Technical Service Bulletin: TSB230228

ReCon® Engines Without Electronic Control Modules (ECM)

Figure 1, Hang Tag Put in Place of the ECM.

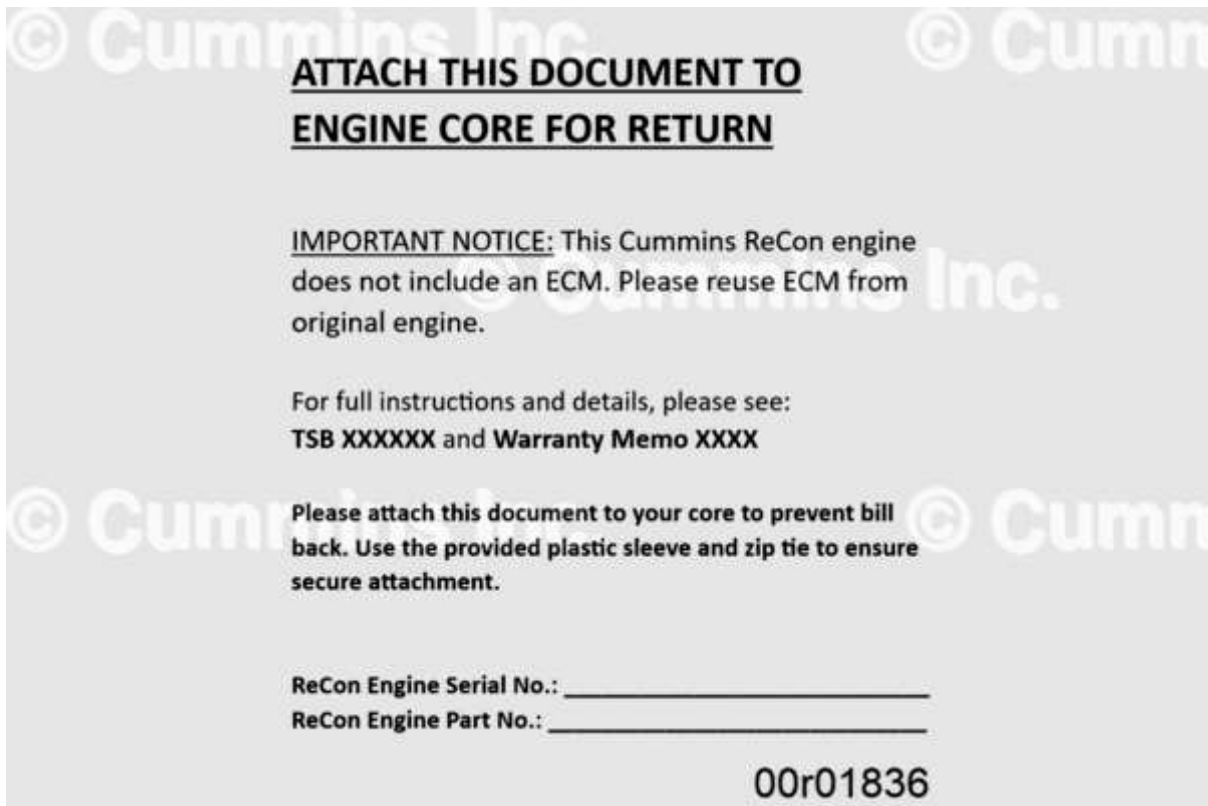
- Once an ECM is installed, an injector reset **must** be completed with INSITE™ electronic service tool. INSITE™ electronic service tool version 7.5.3 or newer is required to complete the injector reset.
- For injector reset instructions, see corresponding Service Manual. Reference Procedure 006-026 in Section 6 (Finishing step of Service Procedure 006-026).
- Update with latest ECM calibration available. See corresponding Service Manual. Reference Procedure 019-032 in Section 19.
- Update the Engine serial number in ECM with ReCon® engine serial number.
- All affected ReCon® engines will arrive with a hang tag (see Figure 1 below) in place of the ECM. This hang tag **must** be attached to the core engine prior to being returned.
